ADDENDUM NO. 1

CITY OF ROLLA
TAXIWAY A RECONSTRUCTION AND TAXIWAY CONNECTOR REHABILITATION
at
ROLLA NATIONAL AIRPORT (VIH)
VICHY, MO

MoDOT Project # 23-056A-1

ADDENDUM NO. 1

SHEET NAME G004
SHEET NO. 4 of 54

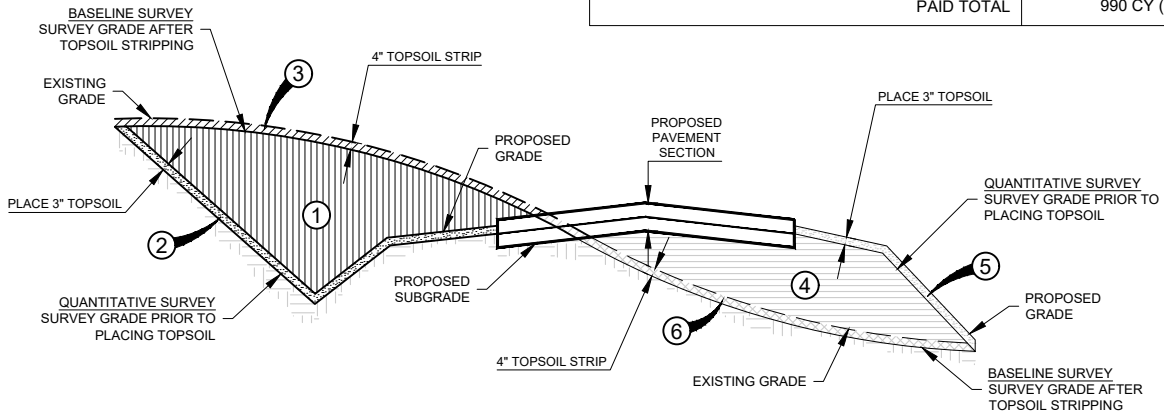
Revision: Updated Detail 1 Earthwork Calculations Detail (Excavation).

Justification: Numbered items were clarified as either paid or incidental to Items P-152a and T-905a. Additionally, a note was added to specify the depths for stripped and placed topsoil.

SHEET NAME
C100
SHEET NO.
20 of 54

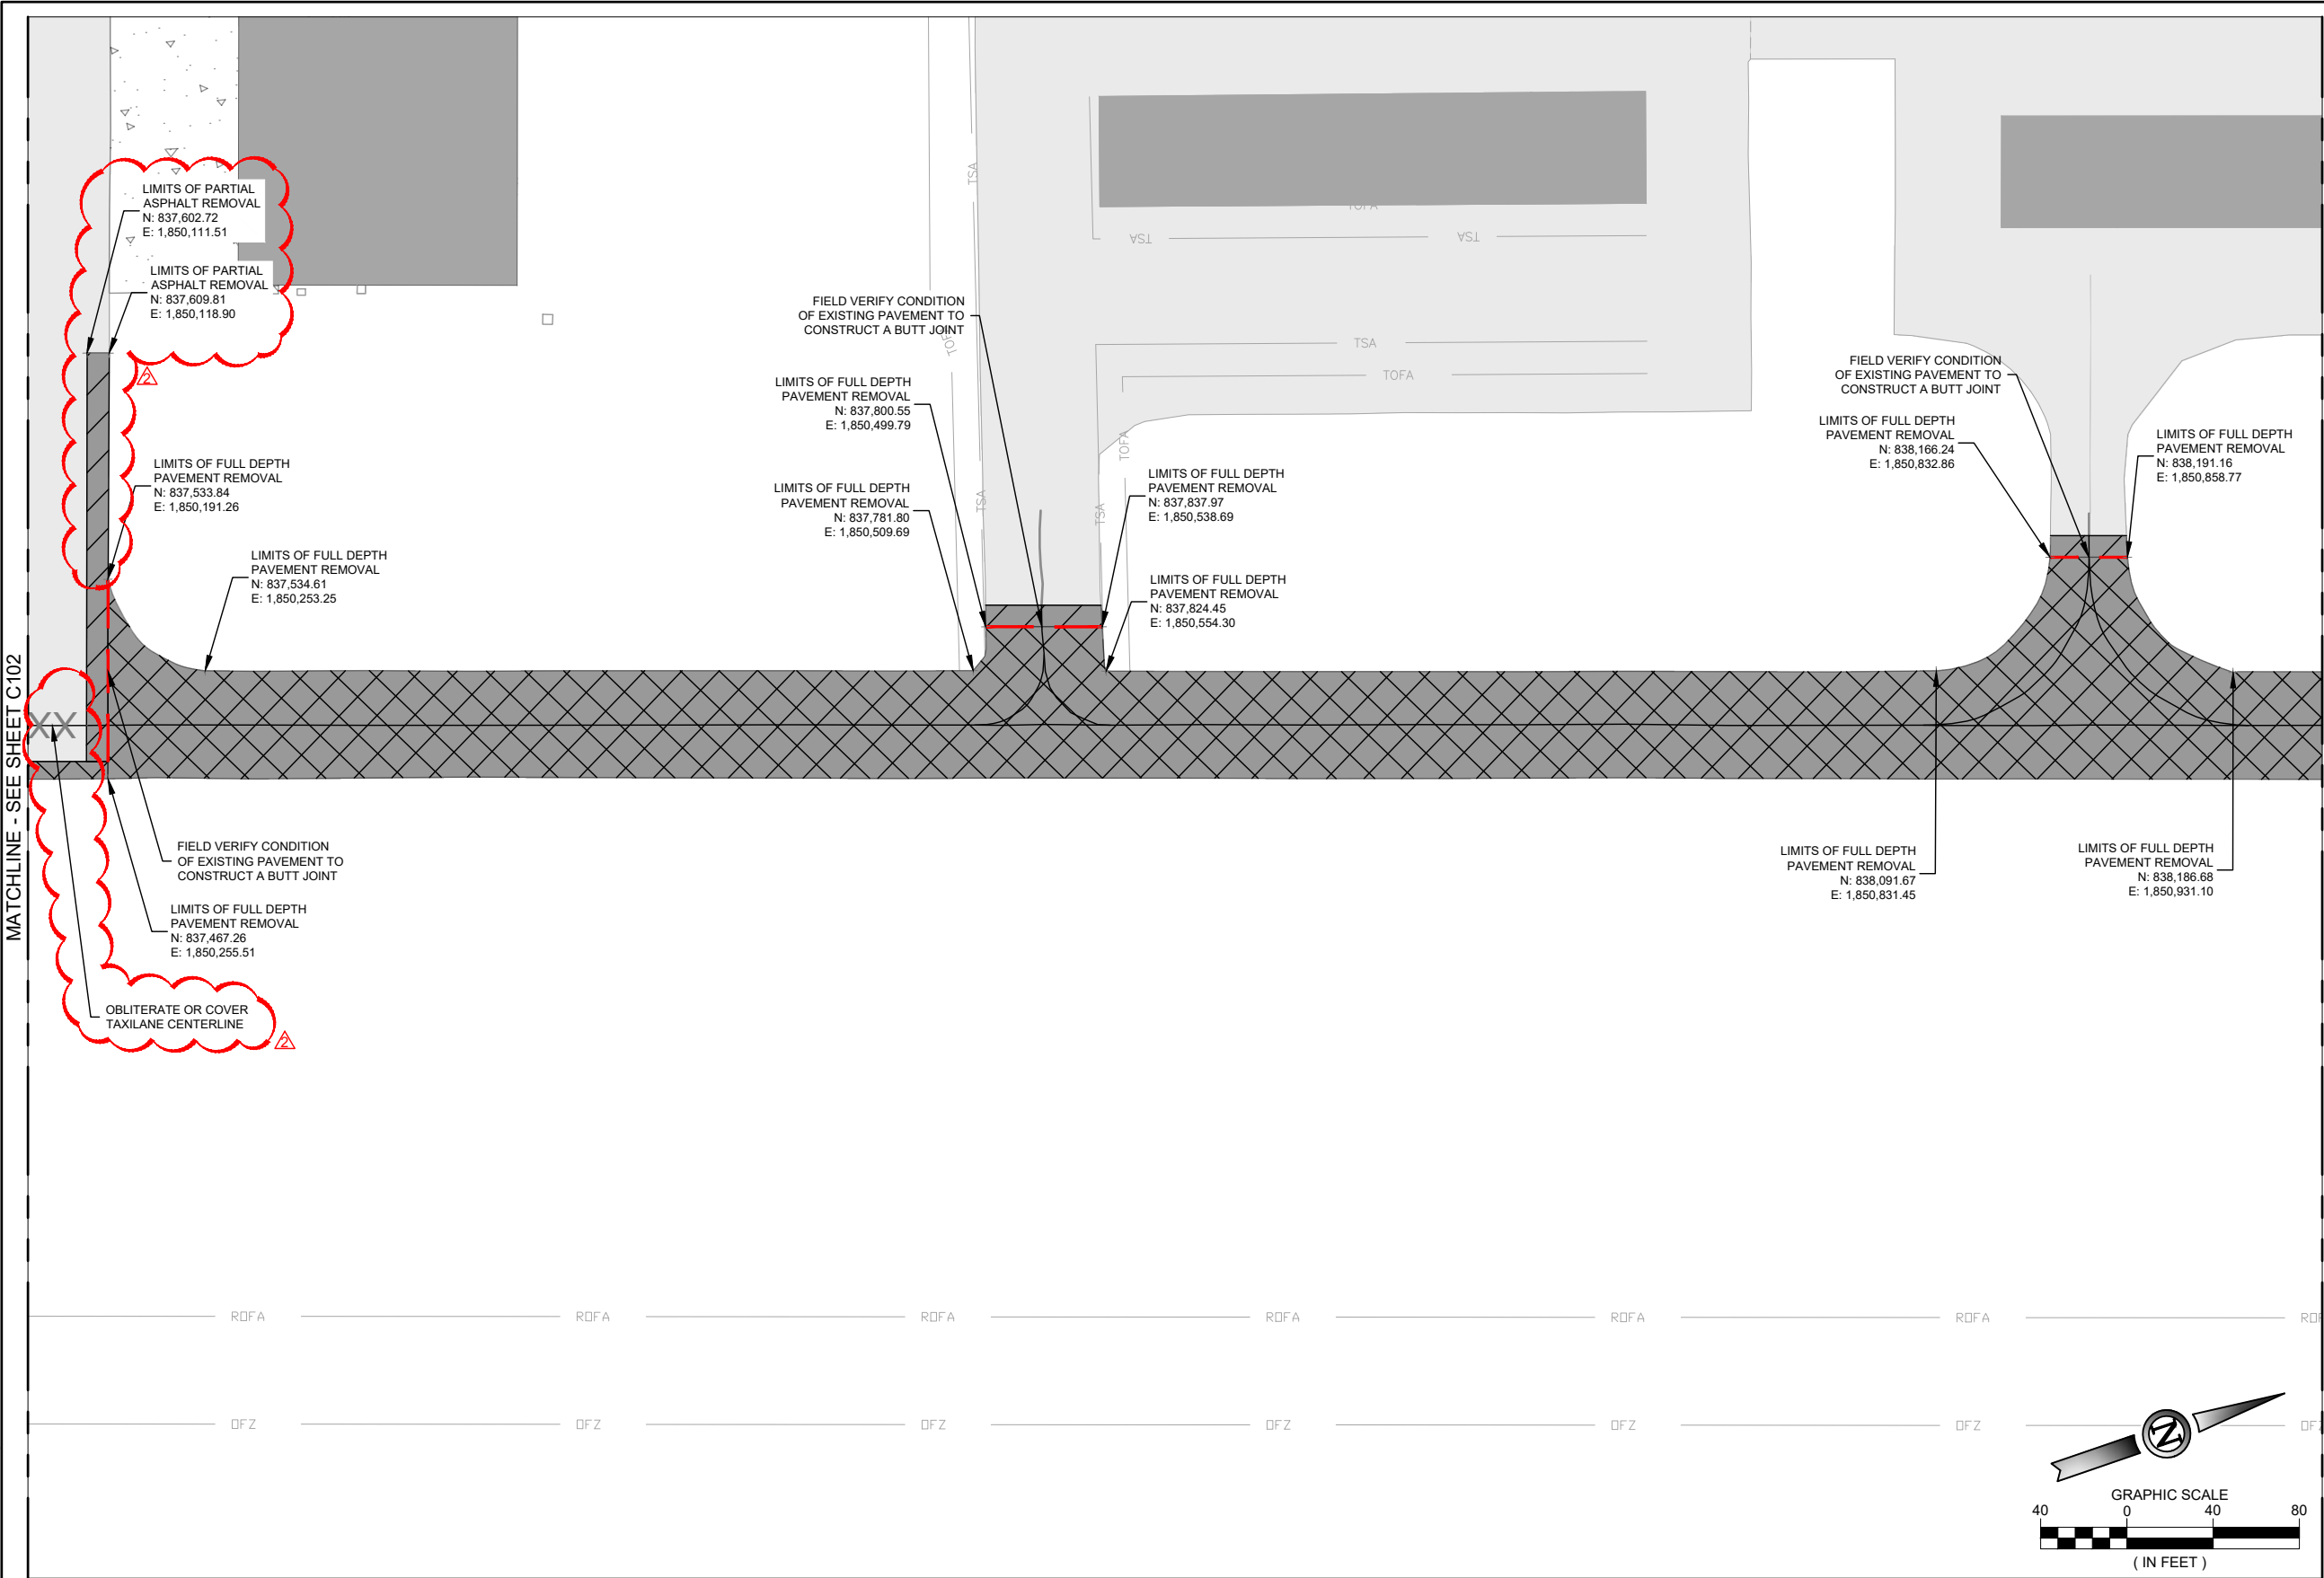
Revision: Added temporary removal of markings leading to closed areas.

Justification: The previously shown butt joint stopped short of the new taper edge. This update ensures the joint extends to the correct location for proper pavement transition.

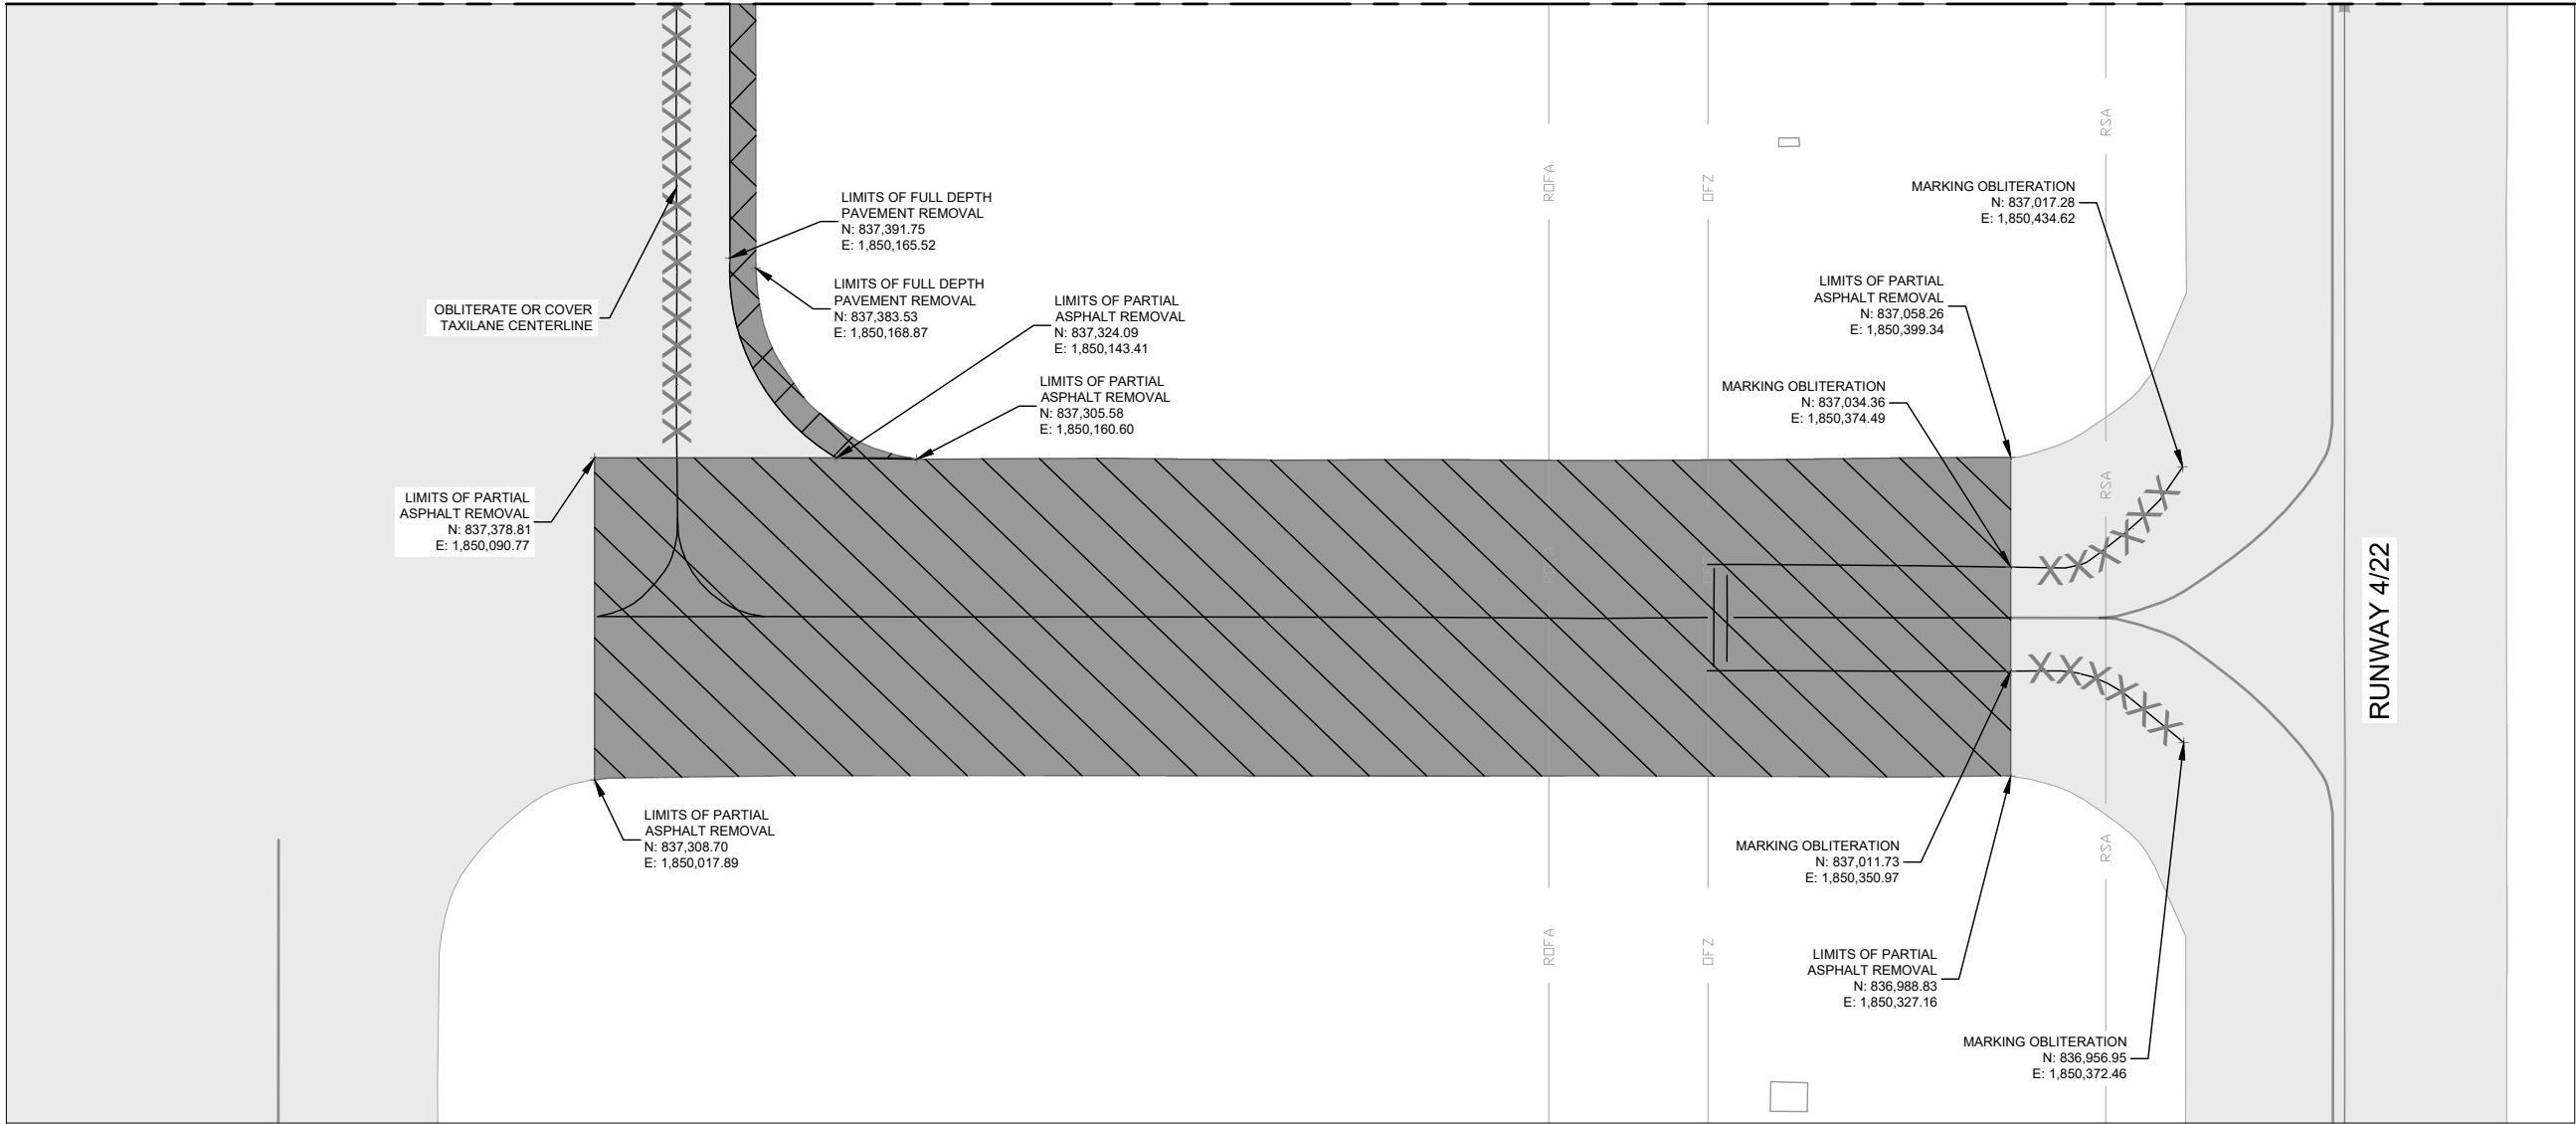
Revision: Added temporary removal of markings leading to closed areas.

Justification: All taxilane centerlines and runway lead-in lines leading to closed taxiway areas must be obliterated or covered in accordance with FAA Advisory Circular 150/5370-2G. Additionally, a matchline was added to reference the viewport containing the remainder of the lead-in line for clarity and continuity.
